Modification Recommended Service Note

P9370B Keysight Streamline Vector Network Analyzer

Serial Numbers: From MY61100288 to MY61100353

Potential lifted front panel overlay

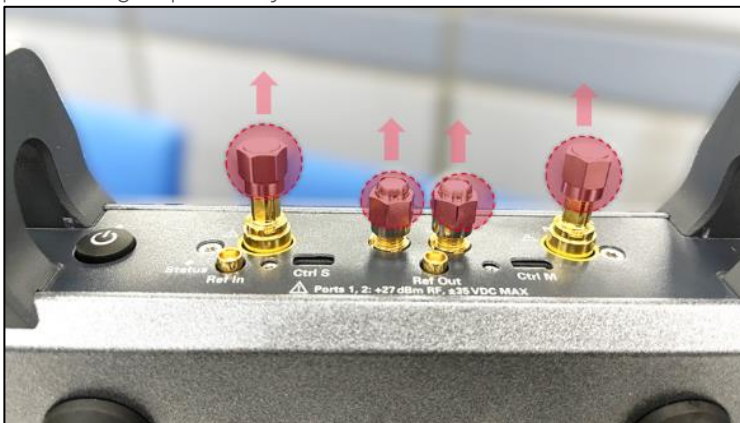
Keysight streamline series vector network analyzer (VNA) of serial number range identified in service note cover page might potentially exhibit the following lifted front panel overlay symptom.

Apart from cosmetic imperfections, the lifted front overlay could have led to non-fully attached *Ctrl S* micro-HDMI cable connector in multi-VNAs setup configuration.

-> Apply this service note only if end users' VNA is exhibiting the following symptom.

Procedure to replace the front panel overlay.

1. Remove the front handles. Detach the 50-ohm termination (LO-In, LO-Out, Port 1 & Port 2) or protecting caps if they are attached to the VNA.

2. Pry open the existing front panel overlay and remove it from front panel.
3. Clean the metal surface thoroughly and ensure it is free of adhesive residue.
4. Affix the new self-adhesive front panel overlay onto the metal surface.
5. Reinstall (reuse) the 50-ohm terminations and port protecting caps accordingly.

6. Reinstall (reuse) the front handles.
